# Olympic Highway Intersection Upgrades

Submissions report

January 2023

**Figure 6: Northern Growth Area**

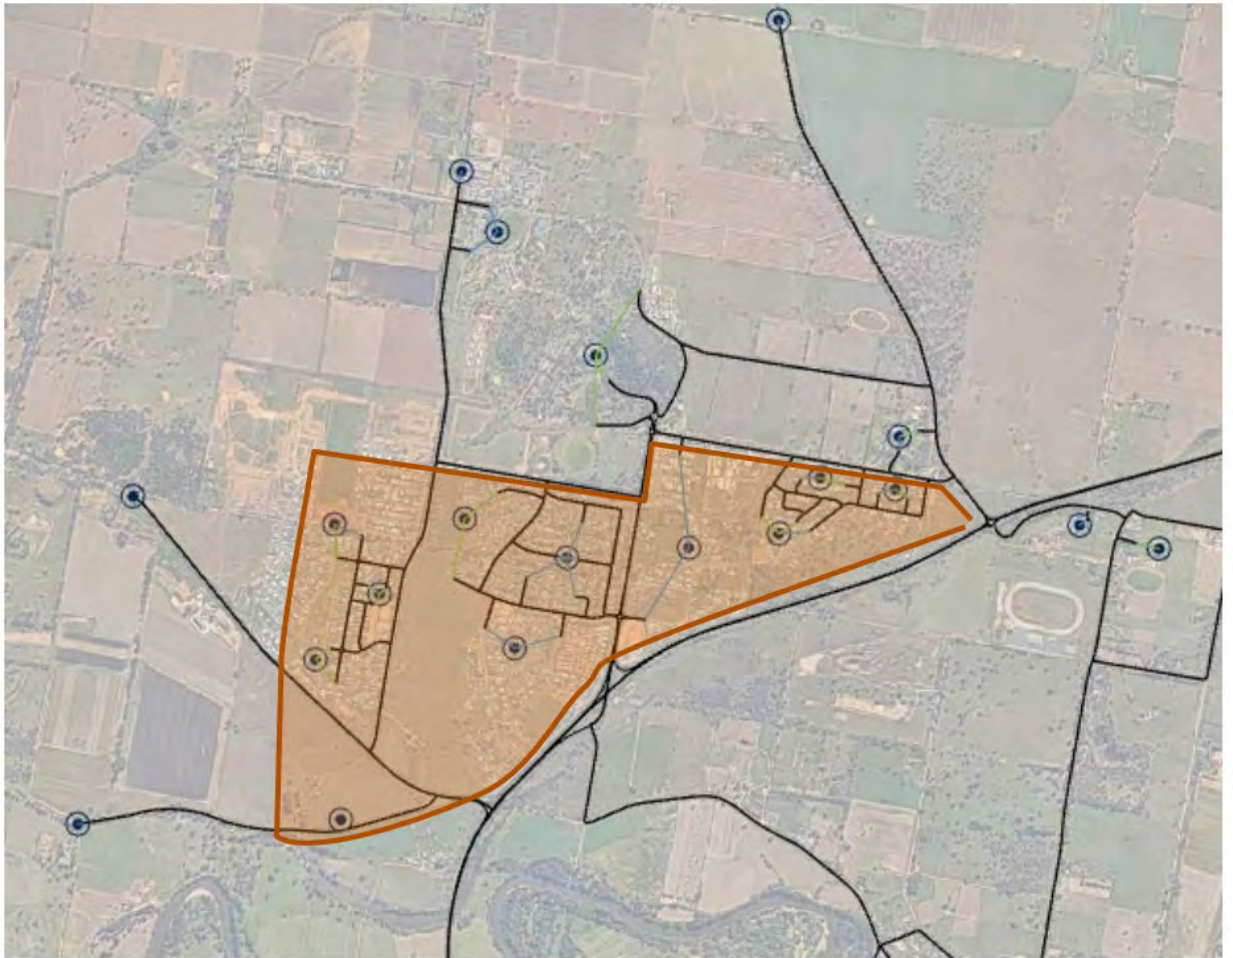
- the traffic modelling carried out for the REF appears unrealistic and does not adequately capture the peak traffic conditions currently or in 2036
- if traffic modelling was done for 8am to 9am, it would show cars travelling southbound from Gobbagombalin Bridge to the CBD
- traffic modelling for school pick up times (between 2.30pm and 4pm) would demonstrate the need for a dedicated exit off Travis Street and Old Narrandera Road (this is discussed further in the 'Proposal design' section)
- request for clarity on how the proposal will provide network efficiency, since traffic modelling indicates travel via Gardiner Street to be quicker

- provide commentary on the traffic modelling claims that the proposal creates efficiency: the model indicates greater delays to traffic
- request to provide clarification of northern growth area traffic numbers
- Travers Street lane configuration regarding traffic merging into a single lane northbound. It is preferred to have a dedicated right turn lane.

Figure 6 below provides a visual depiction of the trips modelled, with the northern growth area shaded. To provide further context and illustrate the level of growth in traffic volumes, particularly in the northern growth area, a review of the model travel zones in Figure 6 below, have been presented in Table 6.

Under the proposed arrangements in the preferred Scenario 8, the Olympic Highway northbound approach to the Travers Street intersection would be configured with two lanes: one through lane and one dedicated right-turn lane. As such, there would be no need for northbound traffic to merge into a single lane. Refer to Figure 7 below.
